United States Patent and Trademark Office

Applic	ation No.	Applicant(s)				
Office Action Summary		10/82	8,825	STONECYPHER, WILLIAM				
		Exami	ner	Art Unit				
		Lanna		3637				
The MAILING DATE of this communication appears on the cover sheet with the correspondence address Period for Reply								
A SHORTENED STATUTORY PERIOD FOR REPLY IS SET TO EXPIRE 3 MONTH(S) OR THIRTY (30) DAYS, WHICHEVER IS LONGER, FROM THE MAILING DATE OF THIS COMMUNICATION. - Extensions of time may be available under the provisions of 37 CFR 1.136(a). In no event, however, may a reply be timely filed after SIX (6) MONTHS from the mailing date of this communication. - If NO period for reply is specified above, the maximum statutory period will apply and will expire SIX (6) MONTHS from the mailing date of this communication. - Failure to reply within the set or extended period for reply will, by statute, cause the application to become ABANDONED (35 U.S.C. § 133). Any reply received by the Office later than three months after the mailing date of this communication, even if timely filed, may reduce any earned patent term adjustment. See 37 CFR 1.704(b).

DETAILED ACTION

Figure 5, Levy (US, 5,729,948)

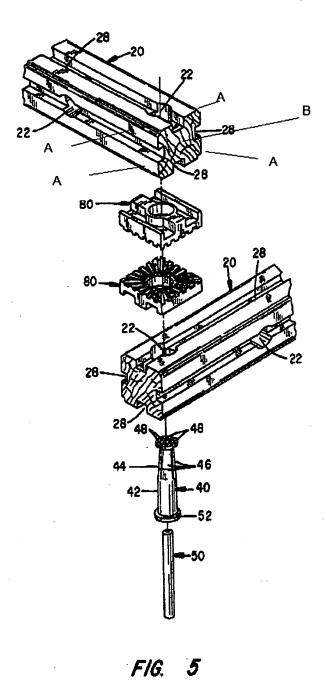
- 6. Claims 2 and 3 rejected under 35 U.S.C. 103(a) as being unpatentable over Levy et al. (US 5,729,948) in view of Soliner (US 5,390,463).
- 7. Regarding claims 2 and 3, Levey et al. discloses four parallel, elongated structural members (A, Fig. 5) having a generally rectangular cross-section, having two ends. Levy et al. also discloses an additional member parallel (B, Fig. 5) and structurally interconnected to at least two of the elongated structural members. However, Levy et al. does not disclose a generally triangular cross-section or a recessed channel having a generally triangular cross-section in one of the four sides. Soliner discloses a truss structure with four triangular channels and cross-sections as shown in Figure 3. Therefore, it would have been obvious to one having ordinary skill in the art at the time of invention to modify Levy et al.'s apparatus to include triangular cross-sections or a recessed channel, as taught by Soliner, to create a different type of truss structure. Endwise coupling a plurality of truss sections is intended use and thus is given no patentable weight.
